Project	IEEE 802.16 Broadband Wireless Access Working Group < http://ieee802.org/16 >	
Title	Credit token based coexistence protocol text update to consider inter-system communication MAC messages encapsulation changes	
Date Submitted	2007-09-07	
Source(s)	David Grandblaise Motorola Labs Parc Les Algorithmes Commune de Saint Aubin 91193 Gif sur Yvette, France	Voice: +33 (0)1 6935 2582 mailto: david.grandblaise@motorola.com
Re:	IEEE 80216h-07/019	
Abstract	Contribution IEEE C802.16h-07/077 has provided text remedy on inter-system communication MAC messages encapsulation. These changes on the messages require adapting consequently some additional text on the credit token based coexistence protocol (CT-CXP) within section 15.4.2.4 and 15.6.2.	
Purpose	Consolidation of draft D2c on credit token based coexistence protocol	
Notice	<i>This document does not represent the agreed views of the IEEE 802.16 Working Group or any of its subgroups. It represents only the views of the participants listed in the "Source(s)" field above. It is offered as a basis for discussion. It is not binding on the contributor(s), who reserve(s) the right to add, amend or withdraw material contained herein.</i>

Figure h71: IP network based CT-CXP requesting procedure

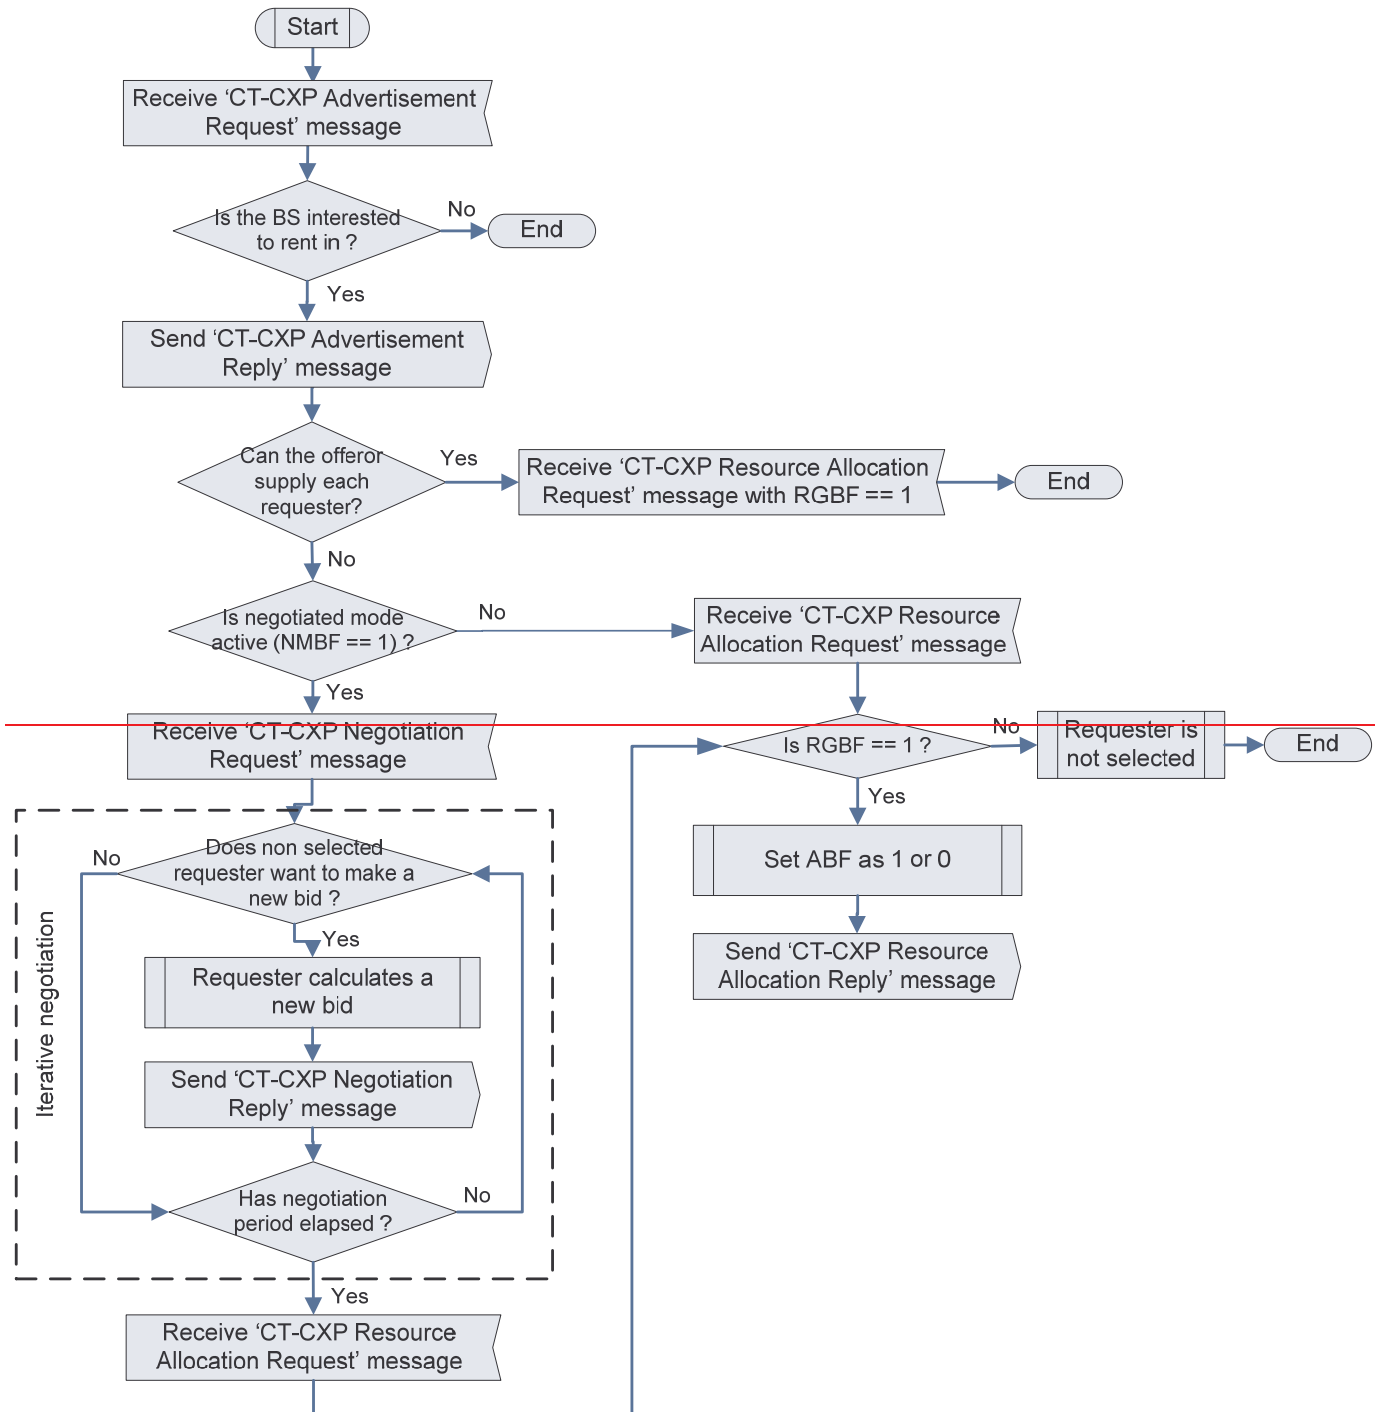
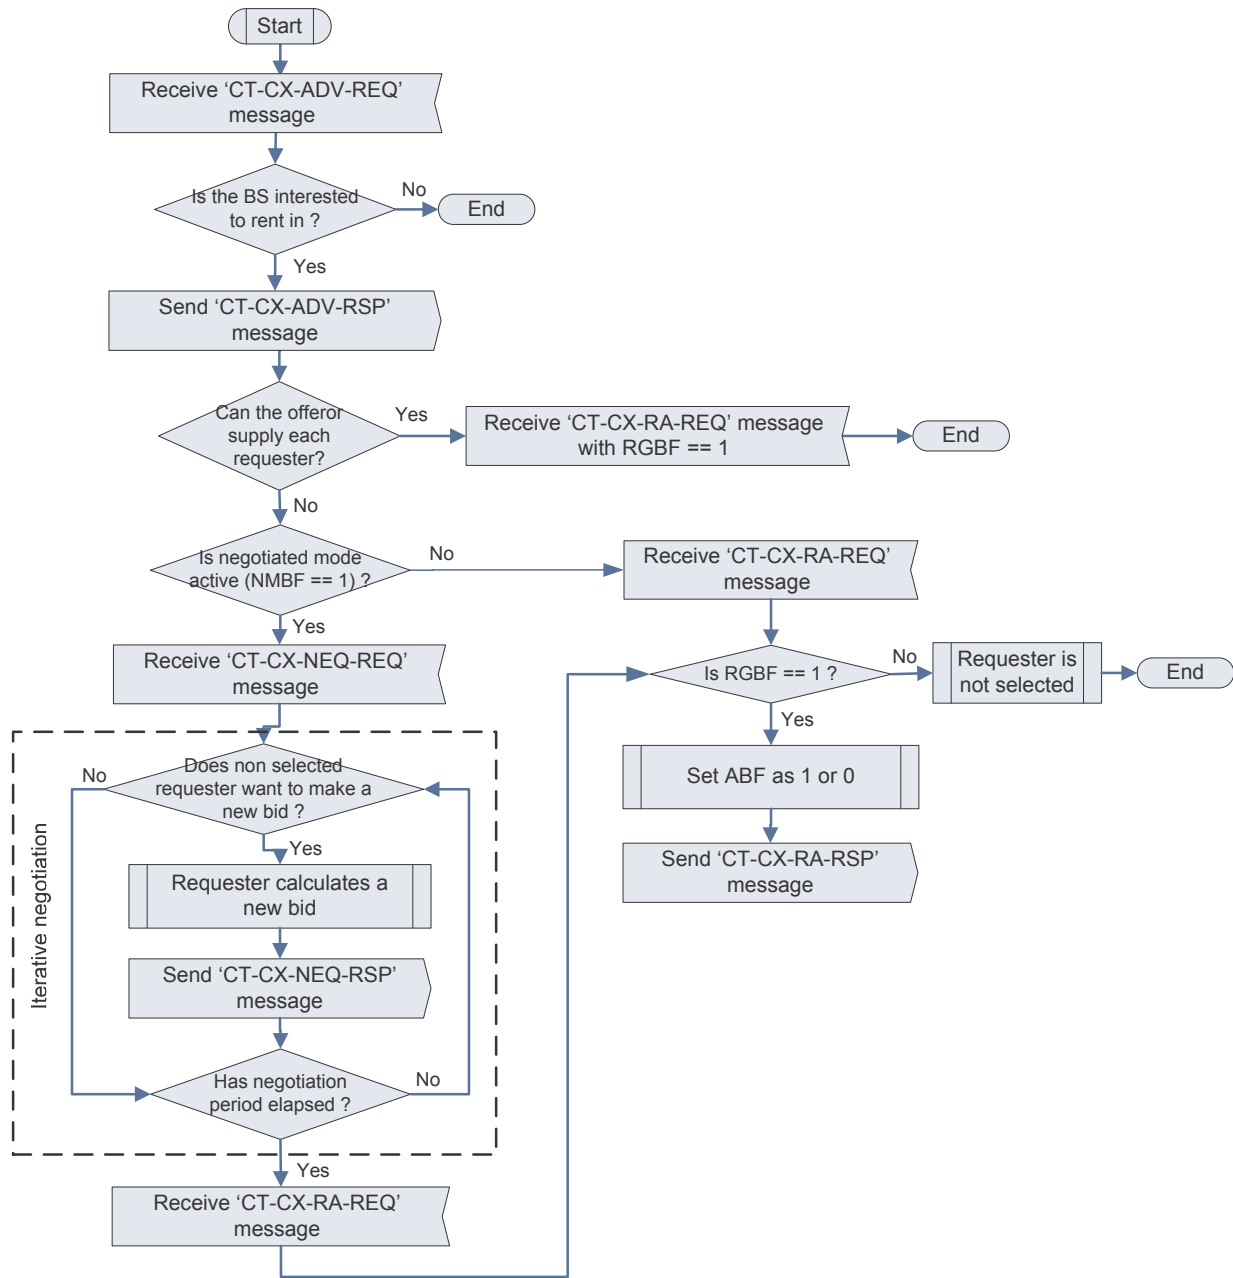
- If a BS is in need of additional resource, meets MNCT requirements, and agrees with the proposed negotiation mode (NMBF) and pricing method (PBF) specified within the CT-CX-ADV-REQ“~~CT-CXP Advertisement Request~~” message, he can submit a bid (within CT-CX-ADV-RSP“~~CT-CXP Advertisement Reply~~” message) upon the reception of the CT-CX-ADV-REQ“~~CT-CXP Advertisement Request~~” message.

- Within the CT-CX-ADV-RSP“~~CT-CXP Advertisement Reply~~” message, the requester informs about the amount of required resource (Rented_resource_amount), the rented in start and end time (Renting_in_start_time, Renting_in_end_time) and its bid (Requester_bid) in term of number of credit tokens bidded per RRU.

- If the non negotiation mode is active (NMBF == 0), same procedure as a) is executed. If the offeror BS can supply to the requester BS, the offeror BS grants the renting resource by setting the Resource Granting Bit Flag (RGBF) to 1 in the CT-CX-RA-REQ“~~CT-CXP Resource Allocation Request~~” message.

- If the negotiation mode is active (NMBF == 1), iterative negotiation occurs between the offeror BS and each requester BS. At each iteration, based on the information Minimum_payoff and Maximal_payoff received from the CT-CX-NEG-REQ“~~CT-CXP Negotiation Request~~” message, the requester decides to submit a new bid (Requester_bid_update) or not. Requester_bid_update

is sent within the [CT-CX-NEG-RSP](#)~~“CT-CXP Negotiation Reply”~~ message. The iterative negotiation occurs until the negotiation period (bounded by End_negotiation_time) is elapsed.

- Upon reception of the [CT-CX-RA-REQ](#)~~“CT-CXP Resource Allocation Request”~~ message, the requester BS knows whether it has been selected or not. If RGBF is set to 1, the requester BS is selected, otherwise (RGBF set to 0) the requester is rejected.

- The requester decides to accept (Acceptation Bit Flag ABF set to 1) or to reject (ABF set to 0) the resource granting based on the Clearing_price information. This information is sent within the [CT-CX-RA-RSP](#)~~“CT-CXP Resource Allocation Reply”~~ message. The method to derive the clearing price is open for the implementation.

[Replace Figure h71 with the following updated one as indicate:]

Figure h74: Inter system over the air communications messages for CT-CXP operations

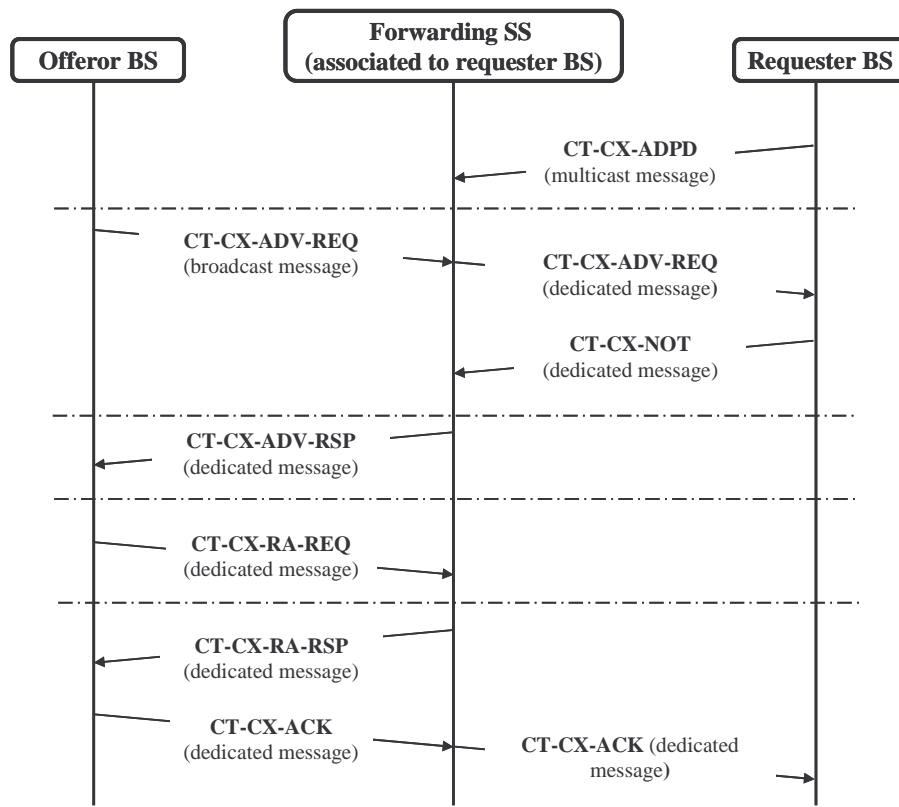
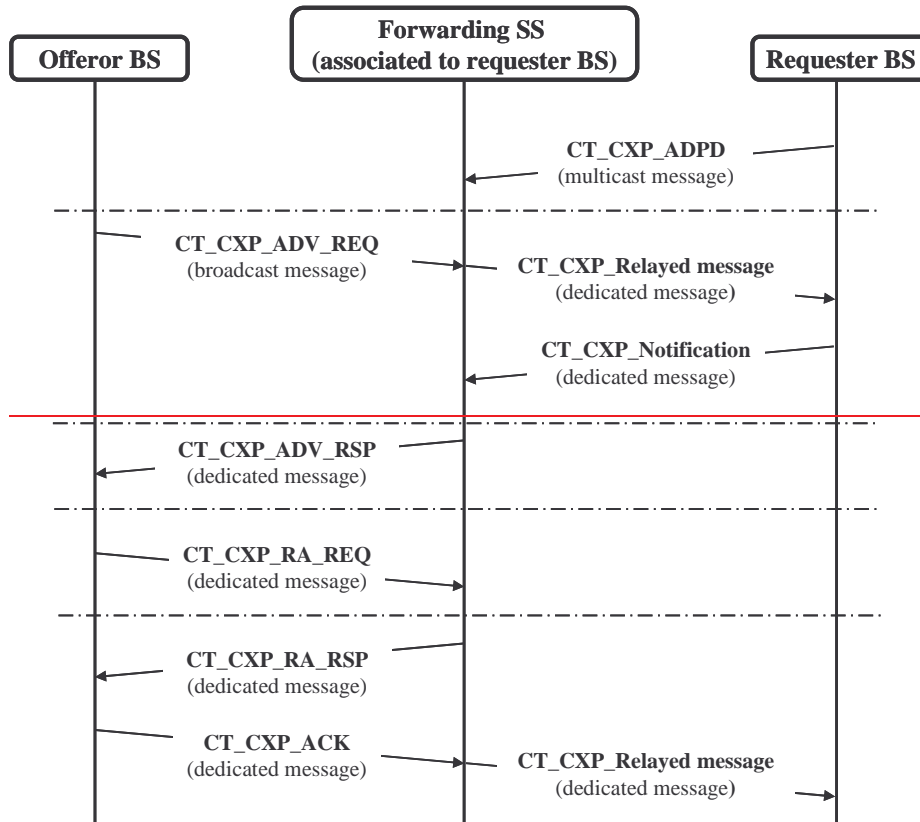
[Replace Figure h74 with the following updated one as indicate:]

~~CT-CX-ADPDCT_CXP_ADPD~~ message (~~CT-CXP-Advertisement-Discovery-Policy-Descriptor~~) is sent from the home requester BS to its associated forwarding SSs as a regular multicast data message. Purpose of ~~CT-CX-ADPDCT_CXP_ADPD~~ is to instruct the attitude of each forwarding SS when it receives ~~CT-CX-ADV-REQCT_CXP_ADV_REQ~~ message. ~~CT-CX-ADPDCT_CXP_ADPD~~ specifies whether the forwarding SS has to forward ~~CT-CX-ADV-REQCT_CXP_ADV_REQ~~ message towards its serving BS (requester BS). If the content of ~~CT-CX-ADV-REQCT_CXP_ADV_REQ~~ message meets the requirements instructed in ~~CT-CX-ADPDCT_CXP_ADPD~~, the forwarding SS actually forwards ~~CT-CX-ADV-REQCT_CXP_ADV_REQ~~ message content from the offeror BS to its serving BS (requester BS). Otherwise, it does not. That way, ~~CT-CX-ADPDCT_CXP_ADPD~~ rules the transmissions from any forwarding SS towards its serving BS. This mechanism avoids having ~~unnecessary~~~~ineessant~~ transmissions from the forwarding SS towards its serving BS when renting conditions proposal specified in ~~CT-CX-ADV-REQCT_CXP_ADV_REQ~~ does not meet the requester BS's need. Any policy can be established and can be adapted dynamically in time by the requester.

The ~~CT-CX-ADV-REQCT_CXP_ADV_REQ~~ message is sent by the offeror BS within the time interval specified in subclause ~~15.6.115.1.5.3~~. If the ~~CT-CX-ADV-REQCT_CXP_ADV_REQ~~ content meets the ~~CT-CX-ADPDCT_CXP_ADPD~~ requirements, the forwarding SS forwards the ~~CT-CX-ADV-REQCT_CXP_ADV_REQ~~ message towards its serving BS followed up the mechanisms specified in subclause ~~15.6.115.1.5.3~~. In order to ensure the ~~CT-CX-ADV-REQCT_CXP_ADV_REQ~~ message is appropriately received by the requester BS, ~~CT-CX-ADV-REQCT_CXP_ADV_REQ~~ message can be sent out by several forwarding SSs. If multiple ~~CT-CX-ADV-REQCT_CXP_ADV_REQ~~ messages are received from different forwarding SSs, the offeror BS selects only one forwarding SS to complete the remaining CT-CXP operations (~~CT-CX-ADV-RSPCT_CXP_ADV_RSP~~, ~~CT-CX-RA-REQCT_CXP_RA_REQ~~, ~~CT-CX-RA-RSPCT_CXP_RA_RSP~~). For that, the offeror BS notifies (~~with CT-CX-NOT~~~~through the notification~~ message) each of the forwarding SS whether or not it should complete the remaining CT-CXP operations. Once the selected forwarding SS has received the ~~CT-CX-ACKCT_CXP_ACK~~ message from the offeror BS, it forwards this message to its serving BS (requester) to confirm that the requester BS can actually use the rented resources for the agreed renting period with the offeror BS.

During the initial phase, as previously mentioned, in case the renting conditions sent in ~~CT-CX-ADPDCT_CXP_ADAP~~ message are not met, the forwarding SS does not forward the ~~CT-CX-ADV-REQCT_CXP_ADV_REQ~~ message to its serving BS (requester). However, upon requester BS recommendation (policy based), even if the renting conditions are not met, the requester BS can allow the forwarding SS to convey the information about the list of channel LC (parameter included in ~~CT-CX-ADV-REQCT_CXP_ADV_REQ~~). This information will provide the serving BS some further information about other radio resources renting opportunities on other channel (frequency domain).
